DAVID PLUMMER & ASSOCIATES

Re: Mediterranean Village Review - #14153
Traffic Impact Study, Parking Analysis & Valet Operations Analysis

David Plummer and Associates (DPA) have completed several reviews of the Traffic Impact Analysis, Shared Parking Analysis, Parking Garage, and Valet Operation Analysis conducted for the proposed Mediterranean Village project. A summary of these components is below.

VEHICULAR CIRCULATION HOTEL DROP-OFF - OPTION #2 “OWNER’S RECOMMENDATION”

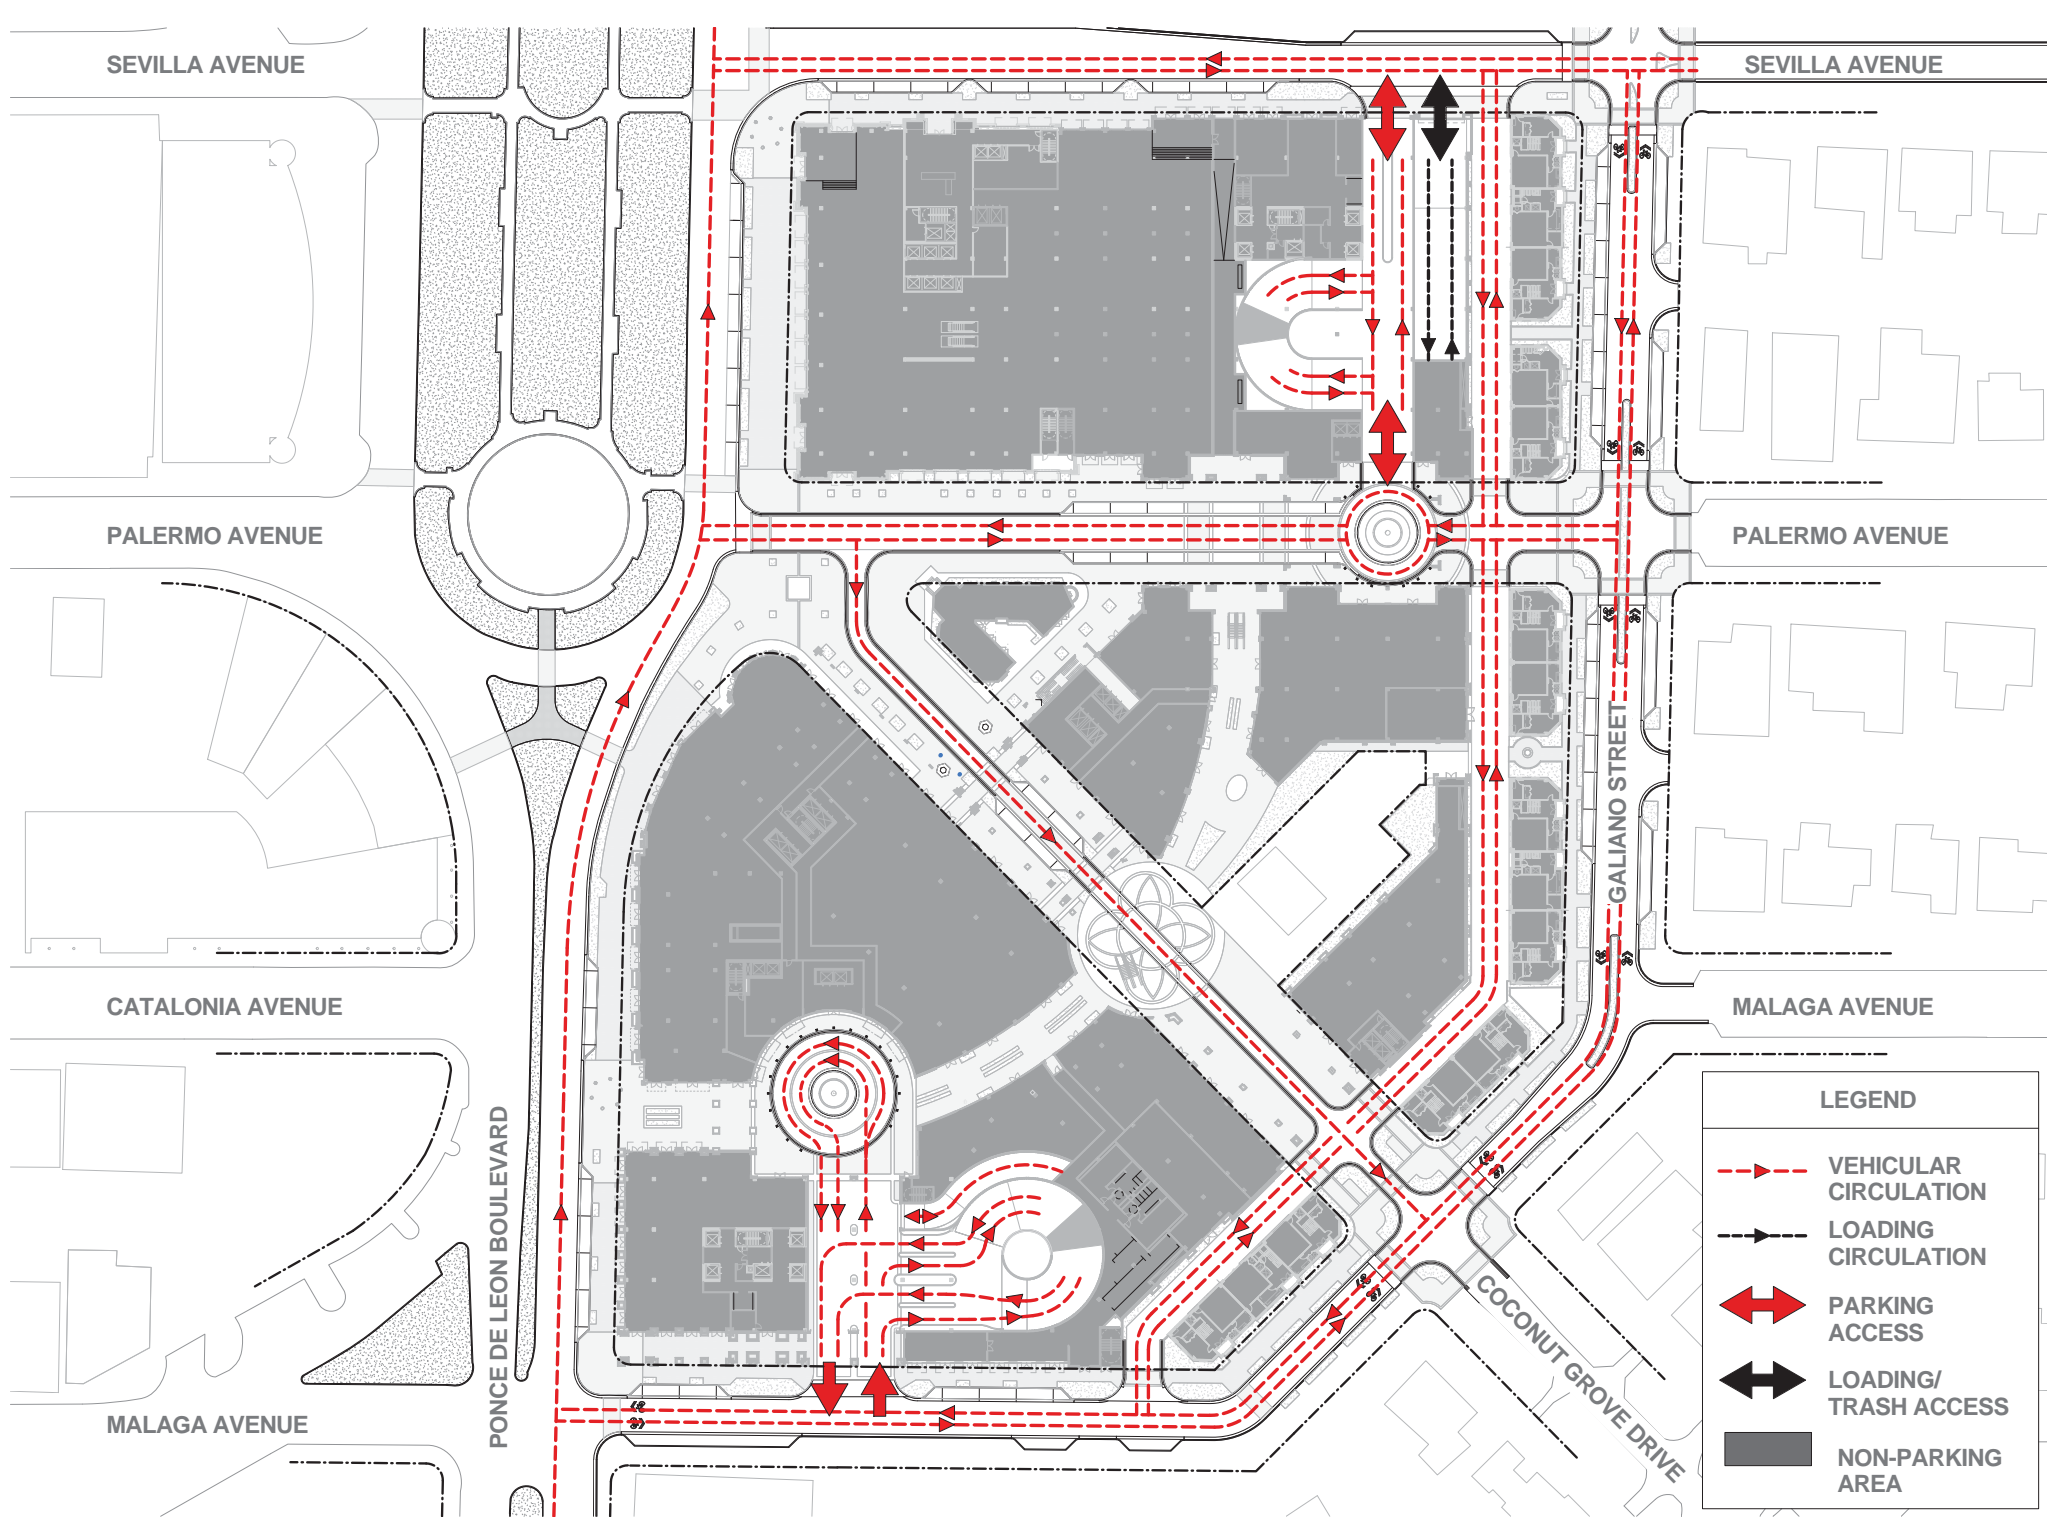
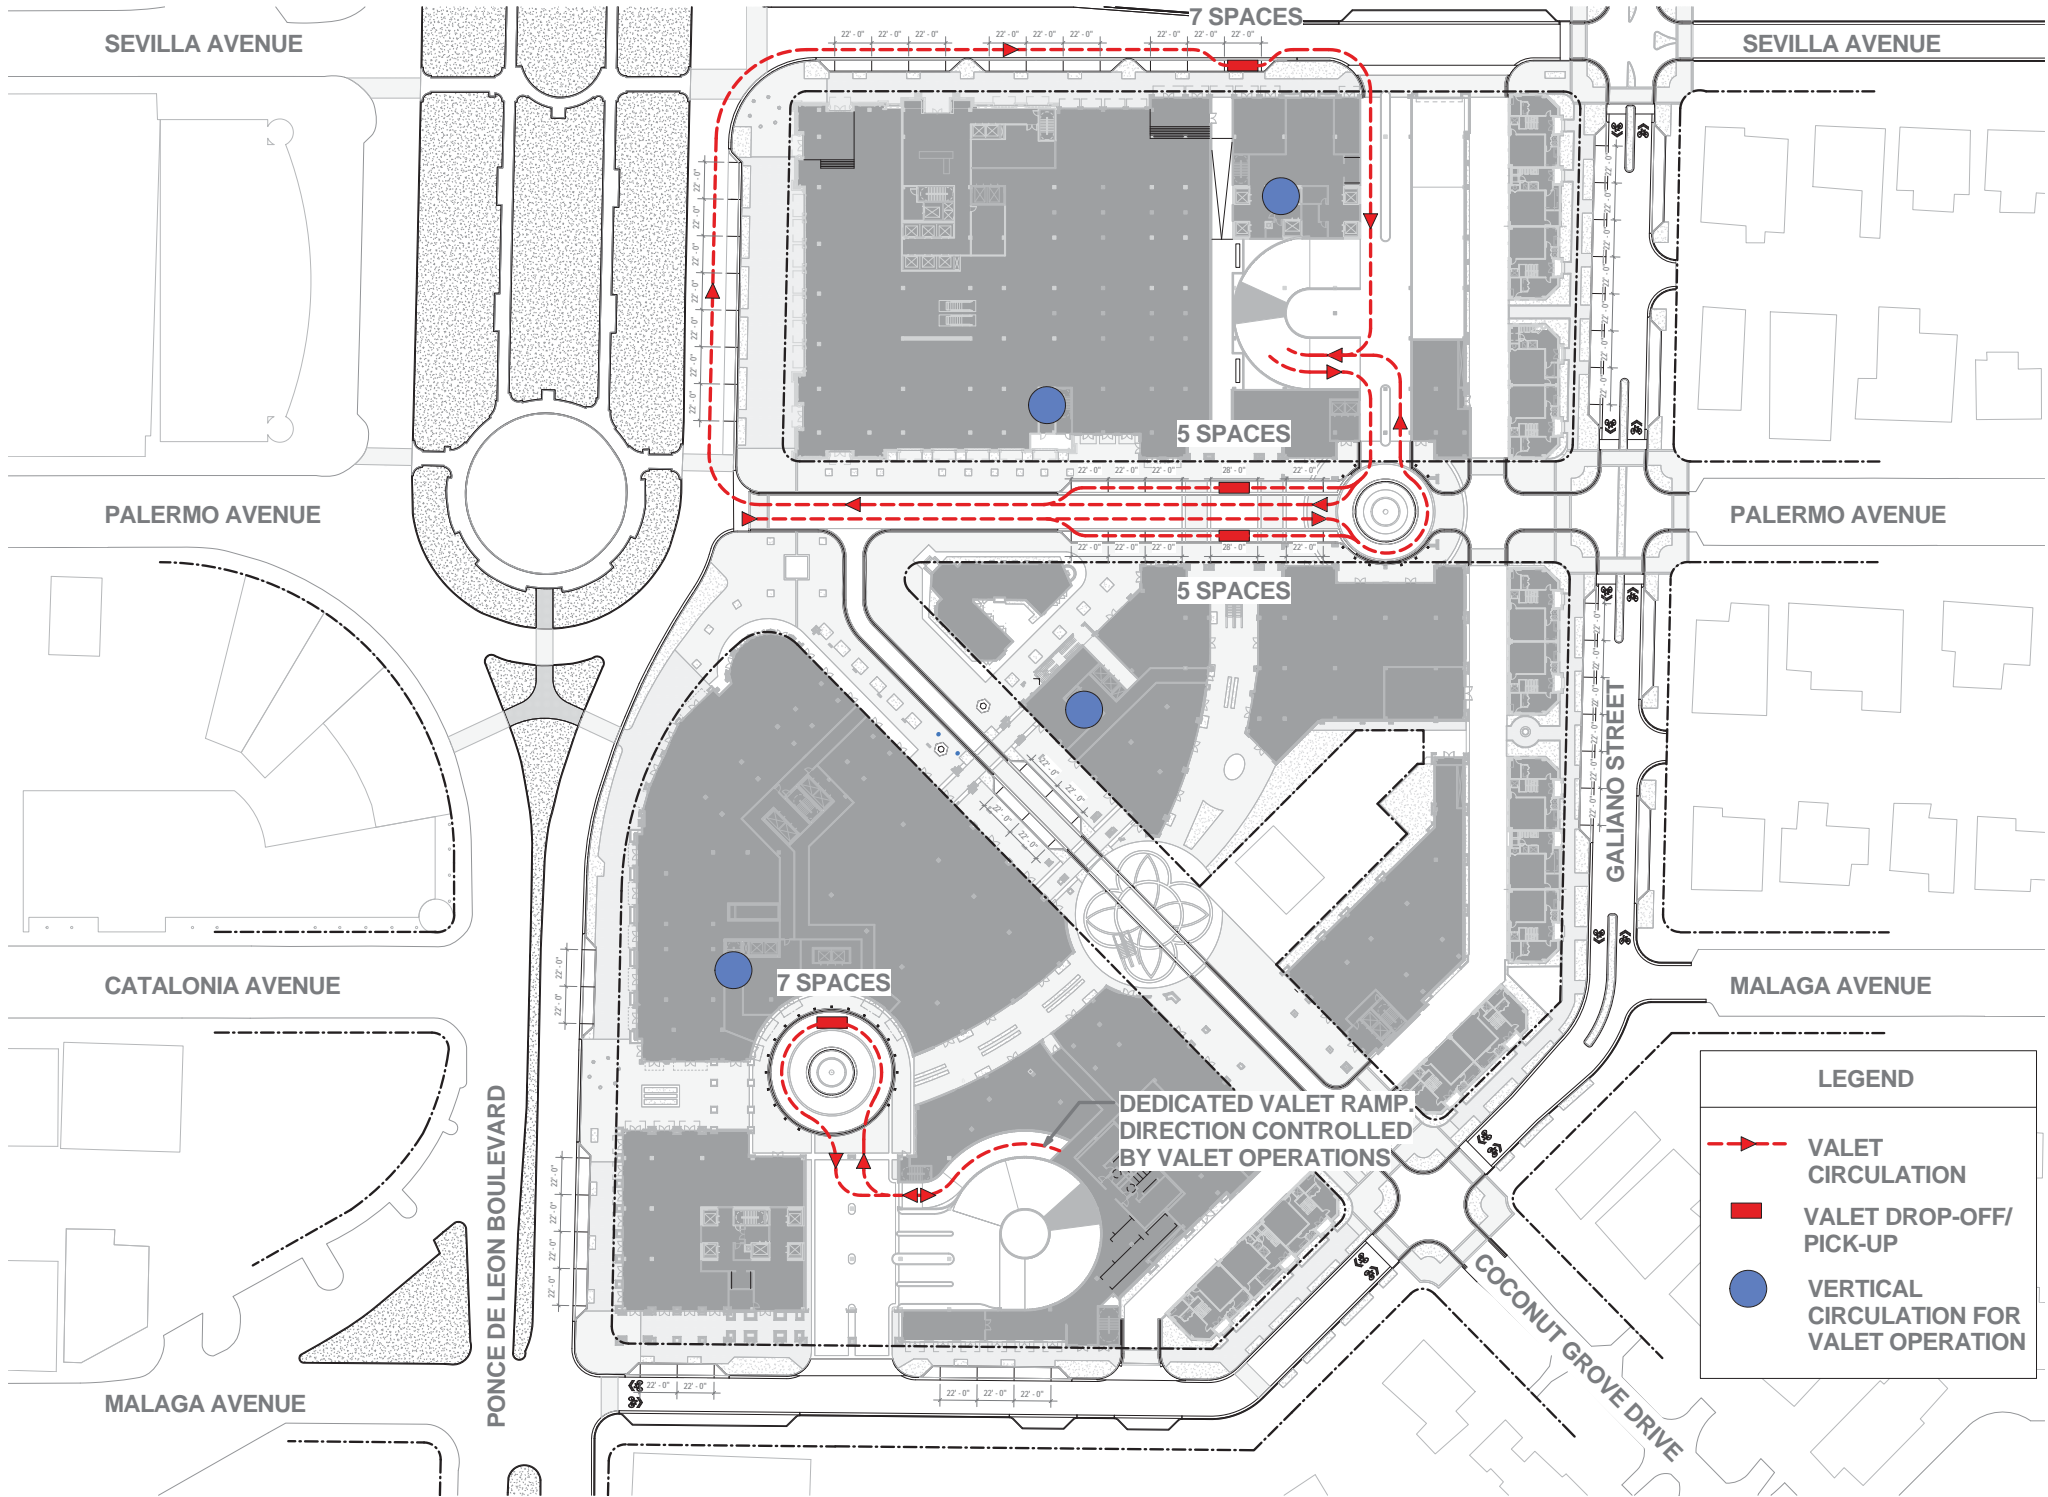
During first reading, the project included direct access to the hotel from Ponce. This access plan for the hotel was acceptable. The project has since changed to address comments from the Commission. Of the newly proposed options, Option 3 is an acceptable alternative and preferable to Option 2 provided that the following conditions are included: 1) the hotel valet ramps will be completely segregated from the Malaga driveway ramping system and no traffic from Malaga would be allowed to access the hotel's porte cochere, and 2) two one-way ramps (similar to the Ponce alternative) or a two-way, two-lane ramp for hotel valet use only is provided. See attachments for hotel access options.
